Access Compliance Report Public Rights-of-Way (Pedestrian Signals)

Main Street: ORTEGA_HWY Cross Street: REATA_RD Location: NW

ADA ID: SGRK211118140824 Signal Type: One Push Button-Non APS Overall Compliance: No Severity Scores: BTN 1: 60 BTN 2: N/A No BTN: N/A

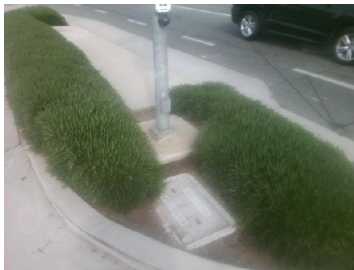
Surveyor Notes: Clear Space on Ramp

OC Std/PROW: R404.3, R404.1, R404.2, R404.7.1, R404.7.3, MUTCD 4e.08

Possible Solutions: Replace Signal Push Button With APS Button. Provide PAR As Indicated. Remove and Replace Clear Space.
